JAFNPP

IMPROVED STANDARD TECHNICAL SPECIFICATIONS (ISTS) CONVERSION

ITS: 3.1.6

Rod Pattern Control

Figure 3.1.7-1 (page 1 of 1)
Sodium Pentaborate Solution Volume
Versus Concentration Requirements

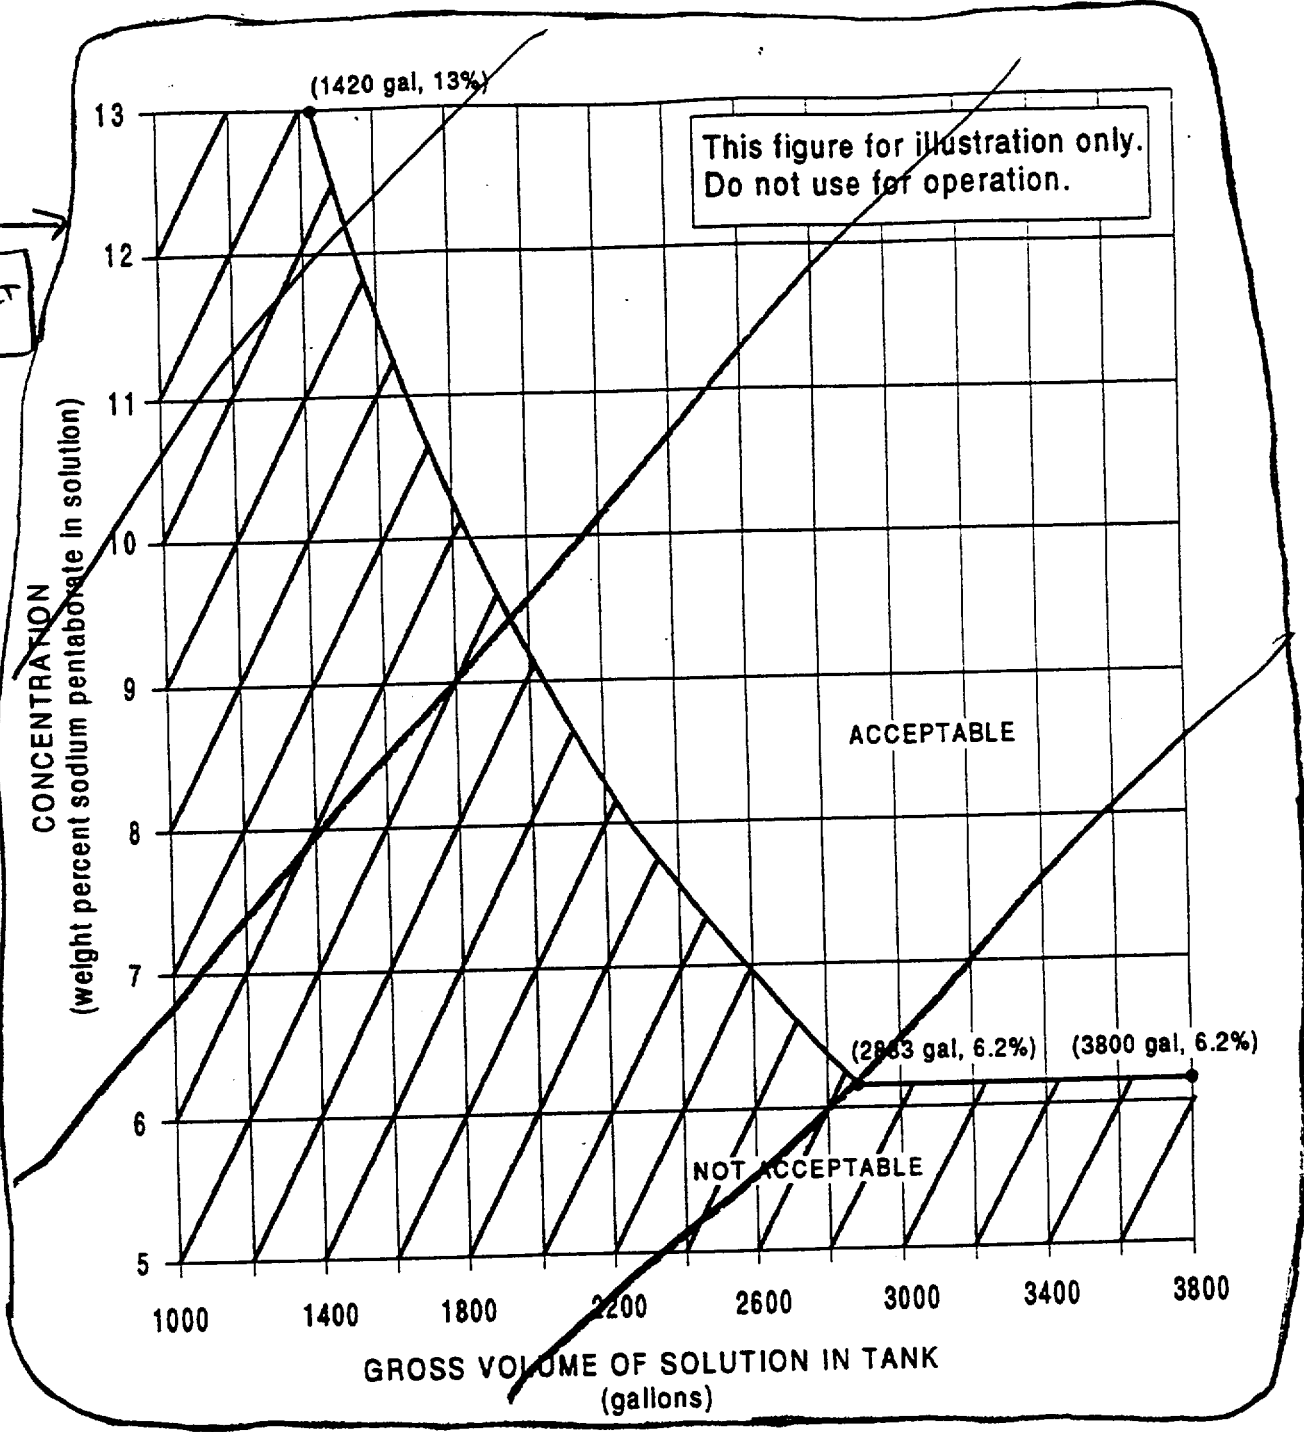
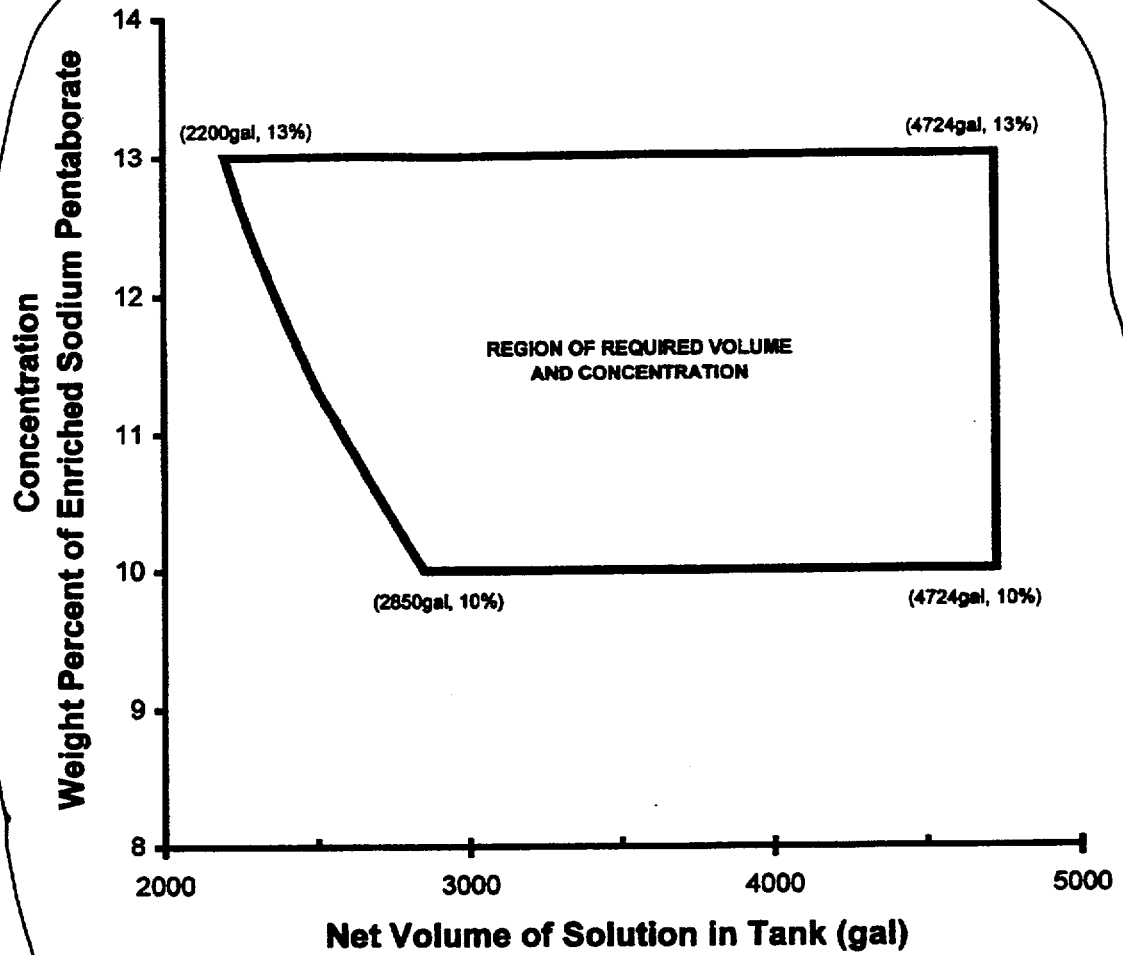
- DB4 NUREG Figures 3.1.7-1 and Figure 3.1.7-2 have been modified in accordance with the current requirements.
- DB5 The brackets have been removed and SR 3.1.7.10 retained in accordance with CTS 4.4.C.4 and DOC M4.

Figure 3.1.7-2 (page 1 of 1)
Sodium Pentaborate Solution Temperature Versus Concentration Requirements

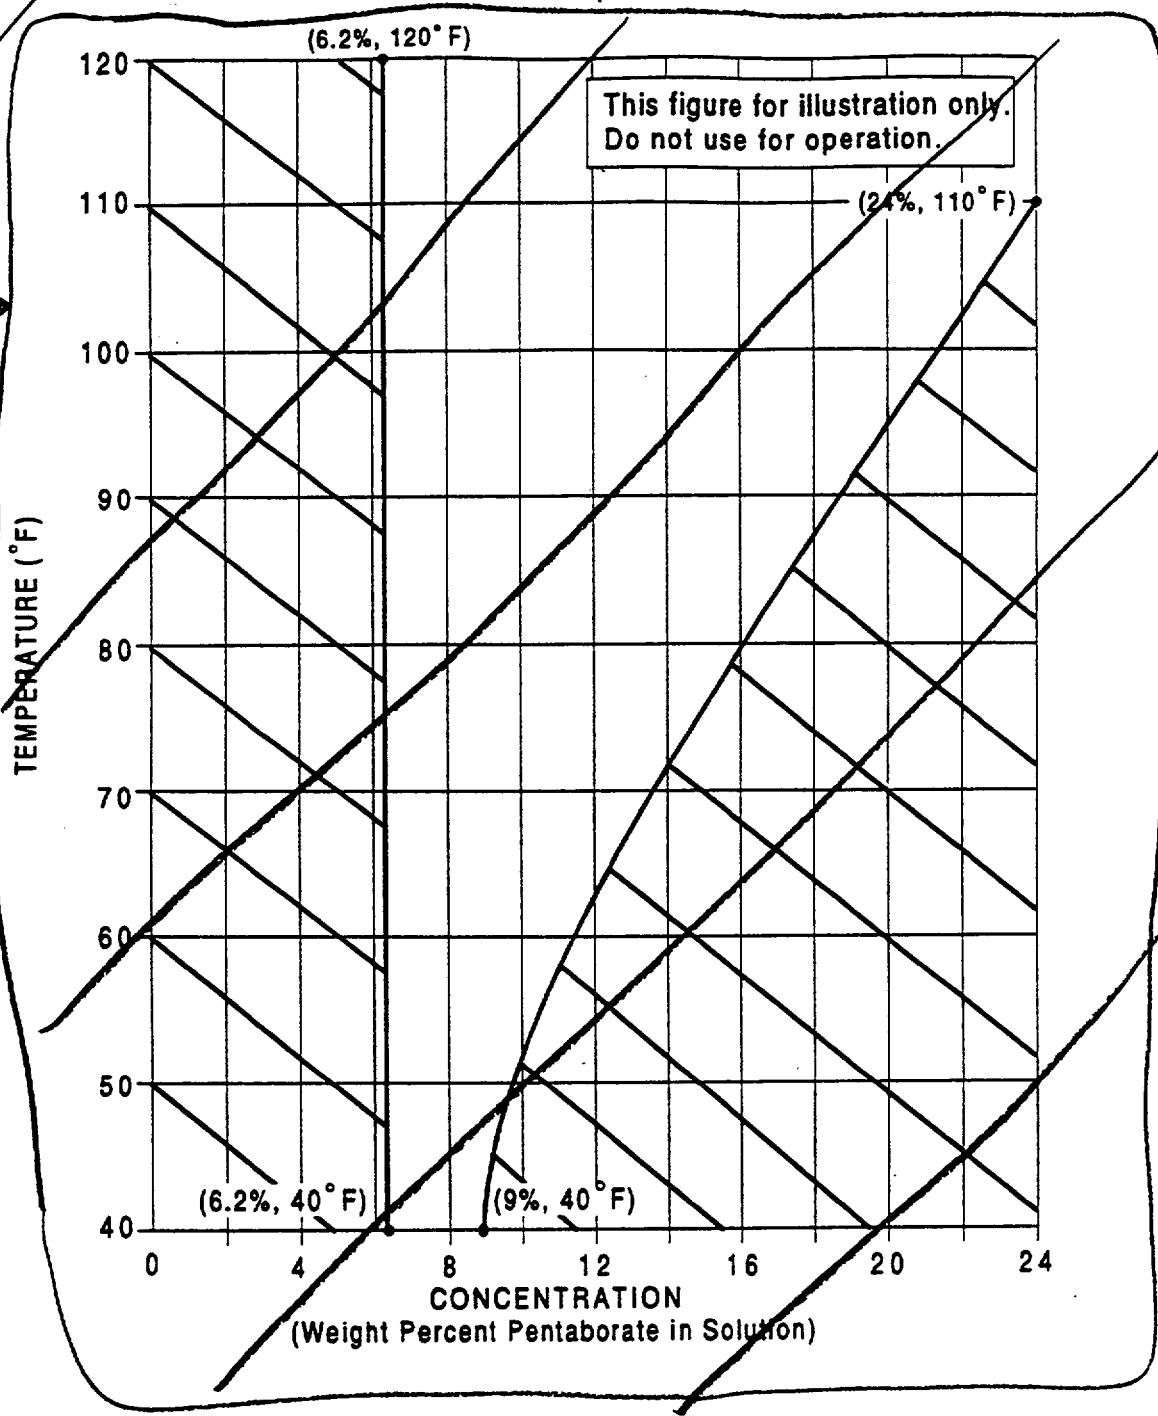
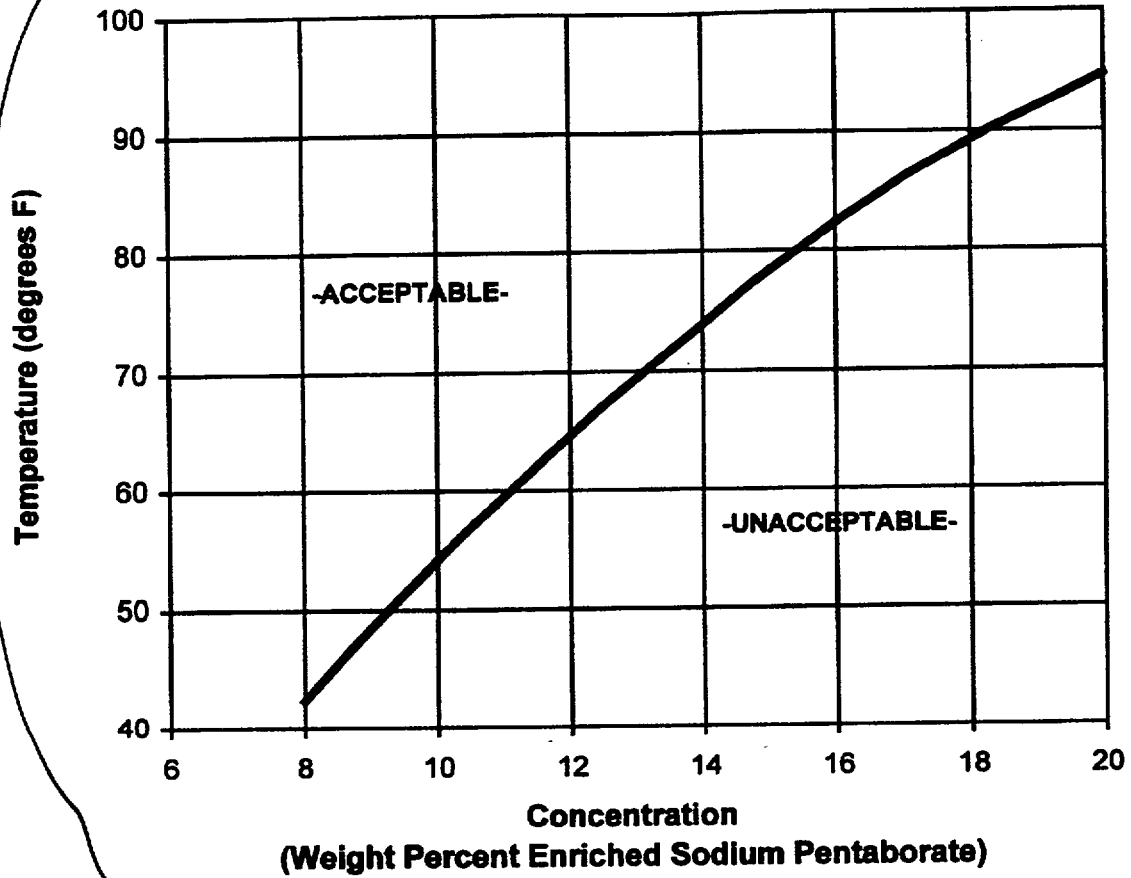
- LA4 The detail in CTS Figure 3.4-2 that the saturation temperature of enriched sodium pentaborate solution curve includes a 10°F margin is proposed to be relocated to the Bases. The requirements in ITS SR 3.1.7.2 to verify the temperature of sodium pentaborate solution is within the limits of Figure 3.1.7-2 (CTS Figure 3.4-2) and Figure 3.1.7-2 (Sodium Pentaborate Solution Temperature Versus Concentration Requirements curve) are adequate to ensure the proper evaluation is performed and therefore help ensure SLC System OPERABILITY. Therefore, the relocated details are not necessary to be in the ITS to provide adequate protection of the public health and safety. Changes to the Bases will be controlled by the provisions of the proposed Bases Control Program described in Chapter 5 of the Technical Specifications.
